Access Compliance Report

Public Rights-of-Way

(Pedestrian Signals)

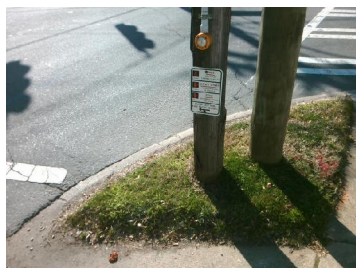
Intersection ID: N/A	Main Street:	Cross Street: N/A	Location: N/A
ADA ID: E6751EC585CA	Signal Type: One Push Button-Non APS	Overall Compliance: No	Severity Score: BTN 1: N/A BTN 2: N/A No BTN: N/A
Codes/Mitigation Info/Possible Solution		Field Measurements/Component Compliance

PROW/ADA: R406.2, R404.7.3

Possible Solutions: Provide Push Button Extension.
